Regulation No. 94

**UNIFORM PROVISIONS CONCERNING THE APPROVAL OF VEHICLES WITH
REGARD TO THE PROTECTION OF THE OCCUPANTS IN THE EVENT OF A
FRONTAL COLLISION,
~~AND THE PROTECTION OF THE OCCUPANTS OF VEHICLES OPERATING ON
ELECTRIC POWER FROM HIGH VOLTAGE AND ELECTROLYTE SPILLAGE AFTER
A FRONTAL COLLISION~~**

Proposal for draft amendments to Regulation No. 94- Rev. 1

The text reproduced below was **prepared by ???** in order to extend the scope of the present Regulation to all kinds of power train systems above a certain working voltage level. The modifications to the existing text of the Regulation R 94 are based on discussions made at [the ELSA adhoc group meeting held in Paris at 22-23 October 2009, and on a working document ECE/Trans/WP.29/GRSP/2009/16 distributed as a document without symbol (informal document No. GRSP-45-03) during the forty-fifth session of the Working Party on Passive Safety (GRSP). The modifications to the existing text of Regulation No. 94 are marked in bold or strikethrough characters].

5.2.8.3 [RESS] retention

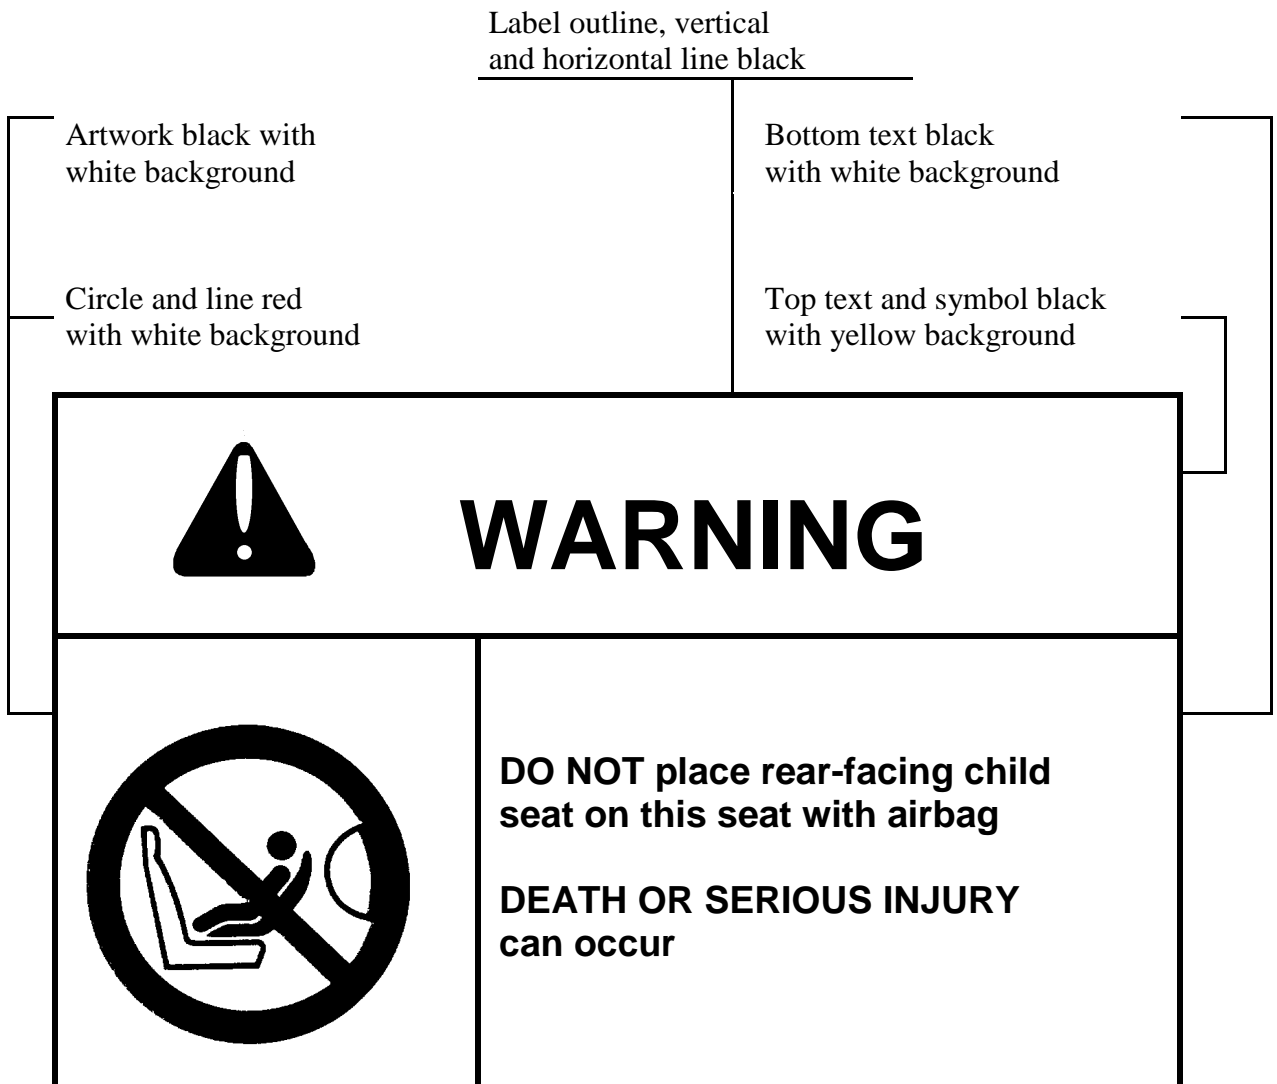
[RESS] located inside the passenger compartment shall remain in the location in which they are installed and [RESS] components shall remain inside **[RESS] boundaries**.

No part of any [RESS] that is located outside the passenger compartment shall enter the passenger compartment during the test procedures.

Figure 1: Measurement of V_b , V_1 , V_2

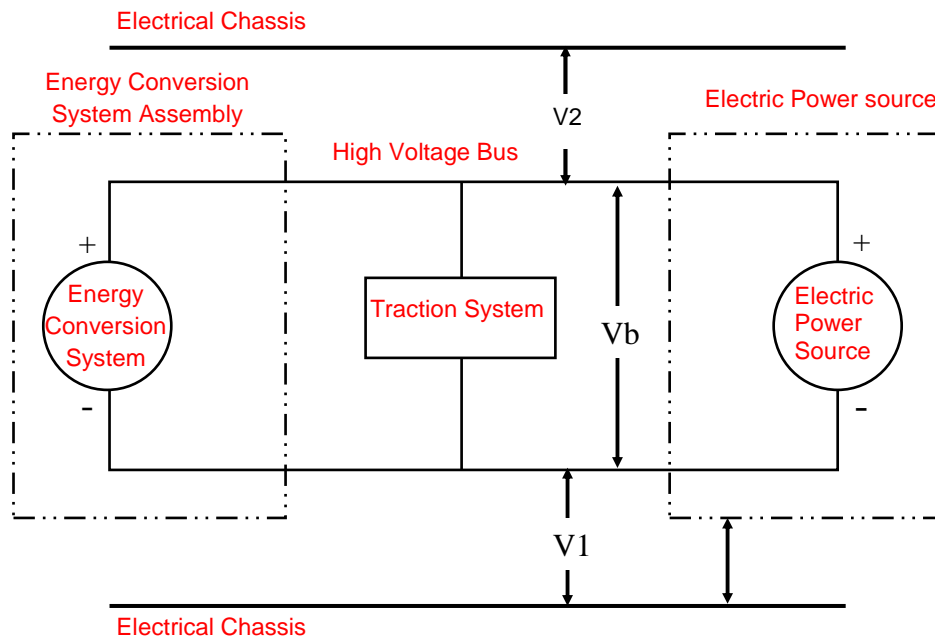
Before the vehicle crash test, measure and record the high voltage bus voltage (V_b) (see Figure 1) and confirm that it is within the operating voltage of the vehicle as defined by the manufacturer.

2.2 The following instructions may be used if voltage is measured.
After the crash test, determine the high voltage bus voltages (V_b , V_1 , V_2) (see Figure 1). If the RESS has exposed conductive parts, measure the voltage V_3 between any exposed conductive parts of it and the electrical chassis.
[The measurement shall be made at 5 seconds after the impact the vehicle coming to rest after each crash test].

Figure 4: Measurement of high voltage bus energy

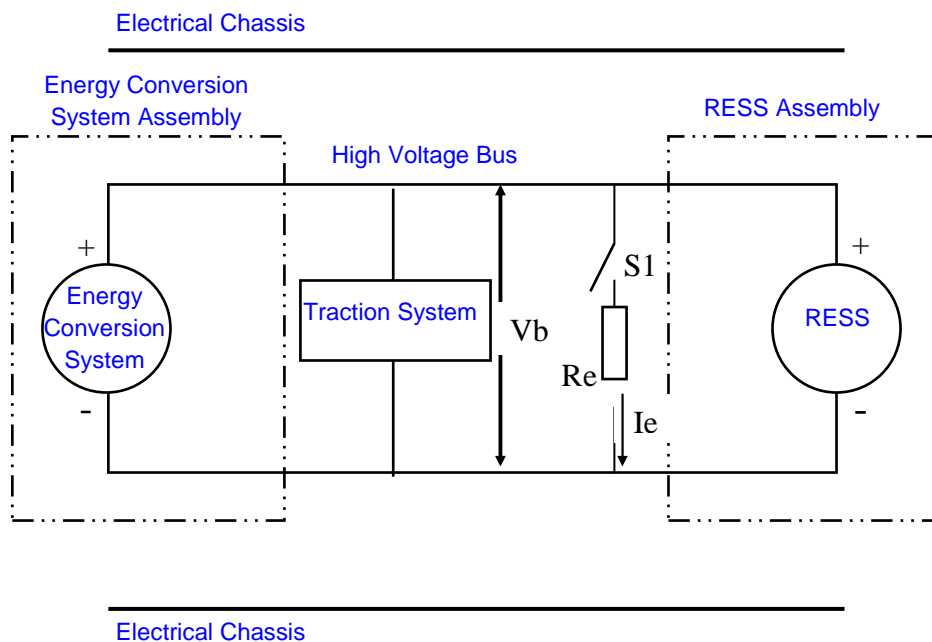
Prior to the **impact** a switch S1 and a known discharge Resistor Re is installed according to Figure 4. [At 5 seconds] after the **impact** the Switch S1 is closed while the voltage Vb and the current Ie is measured and recorded. The product of the voltage Vb and the current Ie is integrated over the period of time starting from the moment when the Switch S1 is closed (tc) until the voltage Vb falls below the high voltage threshold of 30 V AC or 60 V DC (th), resulting in the total energy.

Figure 23: Measurement of V_1'

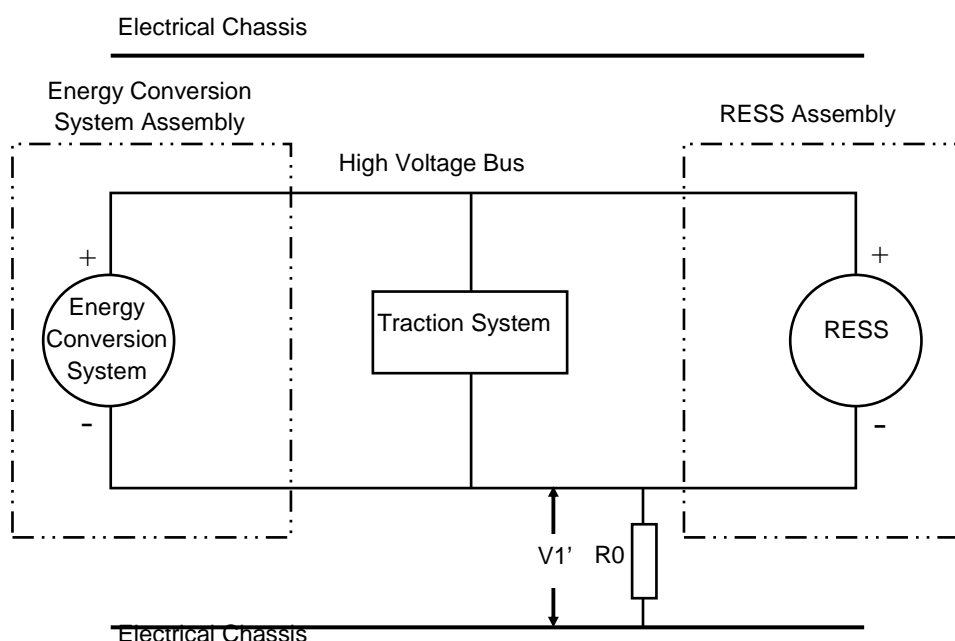
If V_1 is greater than or equal to V_2 , insert a standard known resistance (R_0) between the negative side of the high voltage bus and the electrical chassis. With R_0 installed, measure the voltage (V_1') between the negative side of the high voltage bus and the vehicle electrical chassis (see Figure 2). Calculate the isolation resistance (R_i) according to the formula shown. Divide this electrical isolation resistance value (in Ω) by the working voltage of the high voltage bus (in volts).

Figure 3: Measurement of V_2'

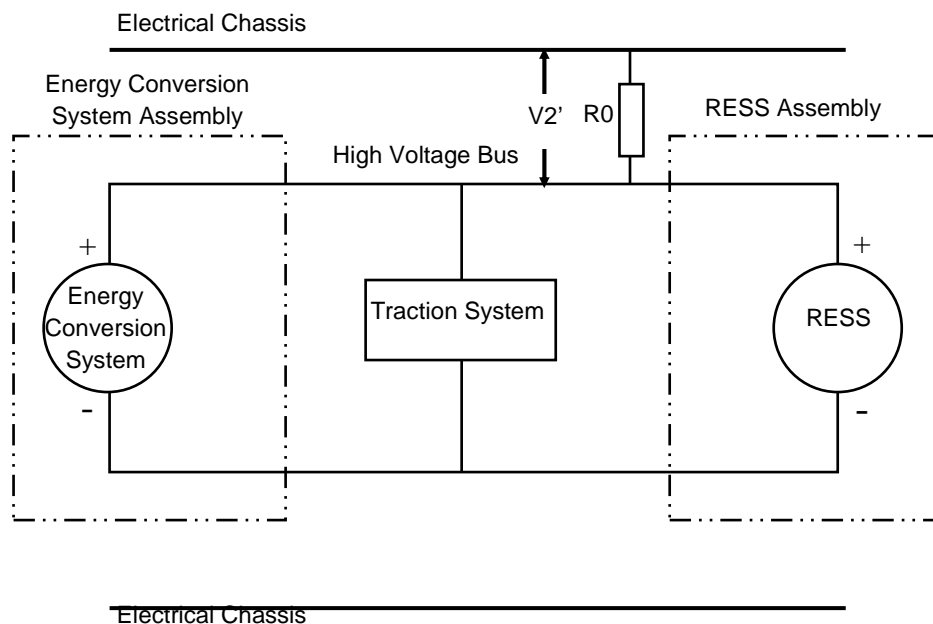
If V_2 is greater than V_1 , insert a standard known resistance (R_0) between the positive side of the high voltage bus and the electrical chassis. With R_0 installed, measure the voltage (V_2') between the positive side of the high voltage bus and the electrical chassis (See Figure 3). Calculate the isolation resistance (R_i) according to the formula shown. Divide this electrical isolation value (in Ω) by the working voltage of the high voltage bus (in volts).
